PLANNING AND DEVELOPMENT SERVICES STAFF REPORT

For Planning Commission Meeting of March 17, 2015

**SUBJECT: Busch's Fresh Food Market Landscape Modification Request
(2020 Green Road)
File No. SP15-002**

SHEET
 Landscape Plan

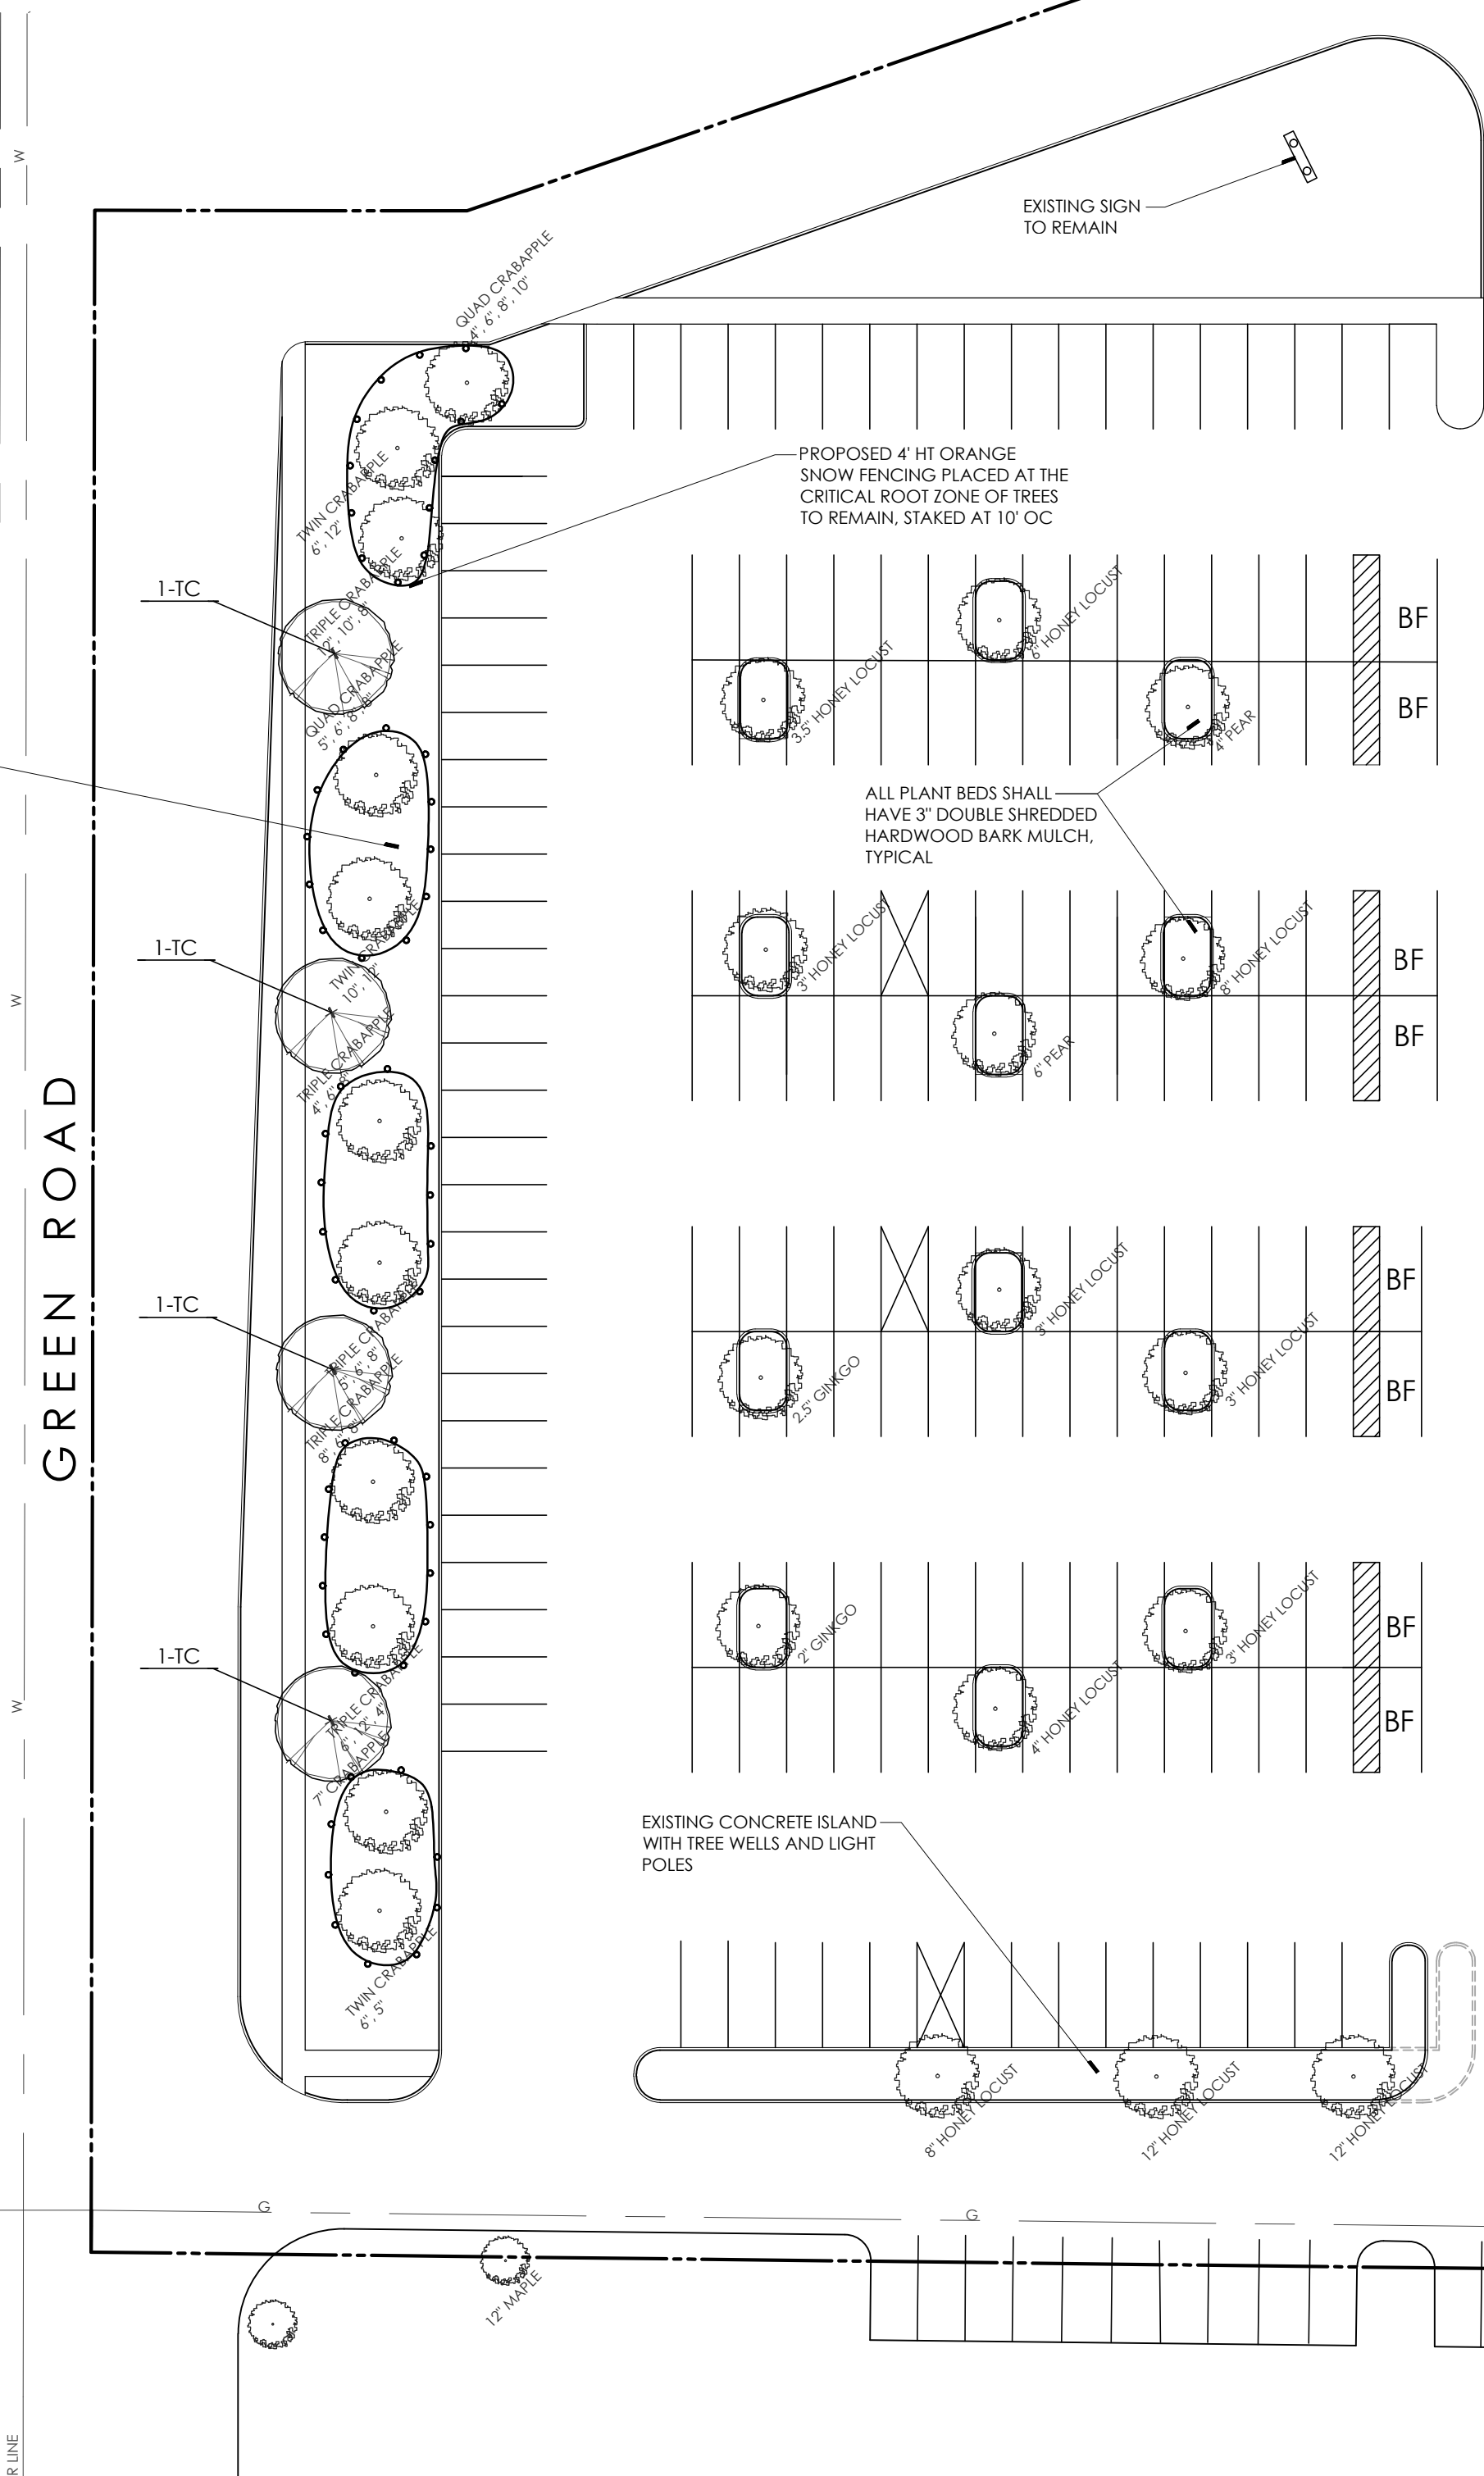
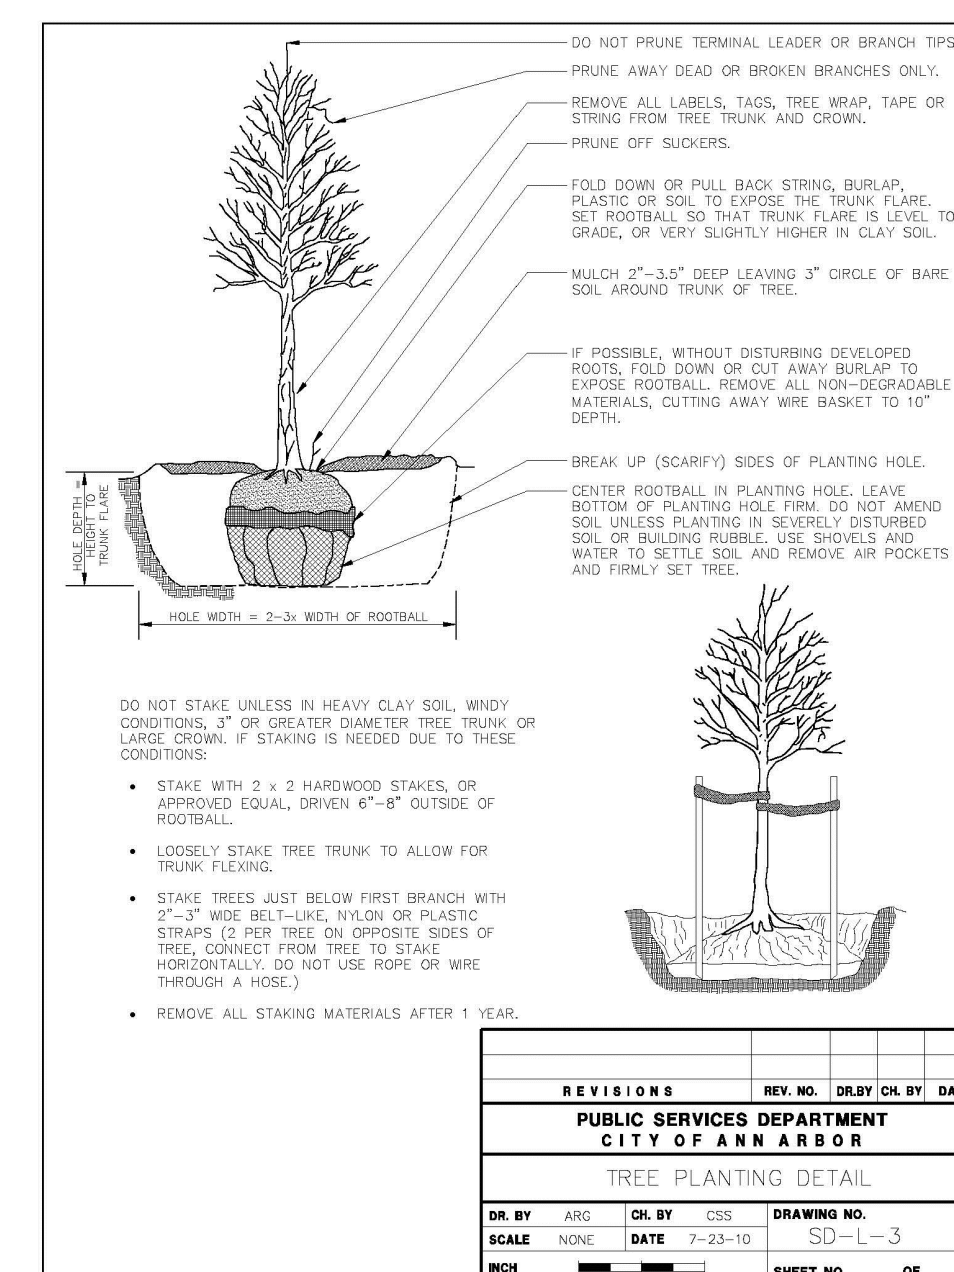
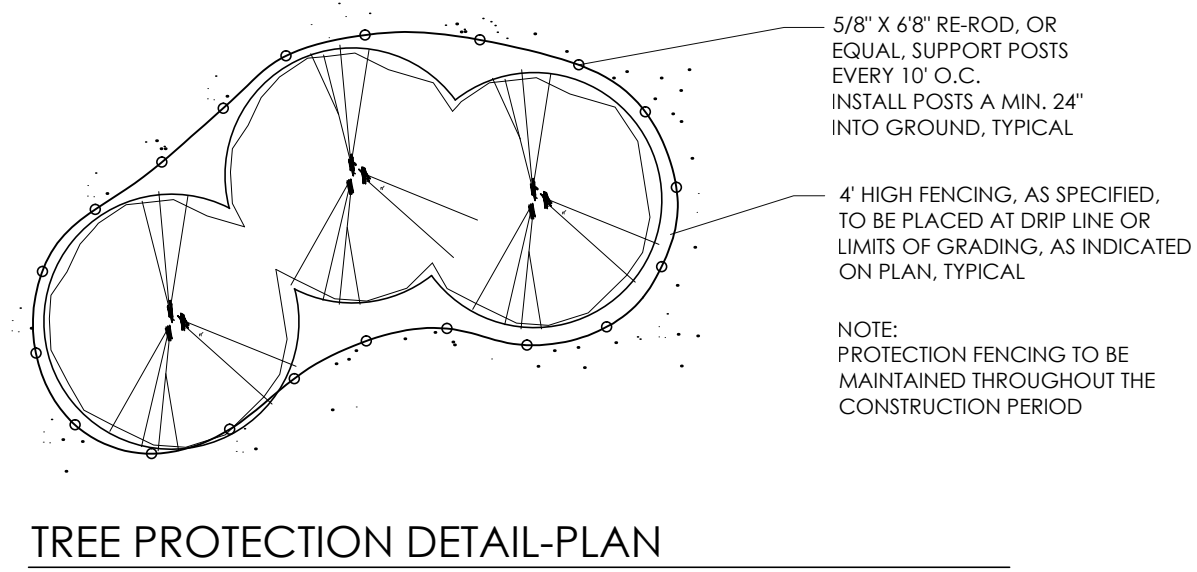
The most recent site plan on file was approved on June 14, 2000 for the Busch's Shopping Center. The current site conditions match the approved site plan. The non-conforming interior landscaping in the existing parking lot includes:

- The vehicular use area is short of 1,420 square feet of interior parking lot landscaping islands and 4 trees.
- The bank of parking spaces facing Green Road exceeds 15 spaces without an island.
- No bioswales exist in the parking lot.

While the intent of the interior landscape requirements is to break up the expanse of pavement and incorporate stormwater infiltration, it is difficult to accomplish this in an existing parking lot with mature landscaping. The petitioner proposes planting 20 additional trees along Green Road and the eastern property line to screen this site in lieu of planting interior parking lot landscaping.

Staff recommends that this petition be **approved** because the modifications are consistent with the intent of the ordinance and are associated with a previously approved site plan.

Urban Forestry and Natural Resources Planning Coordinator- Staff supports the petitioner's request for a landscape modification for this site.
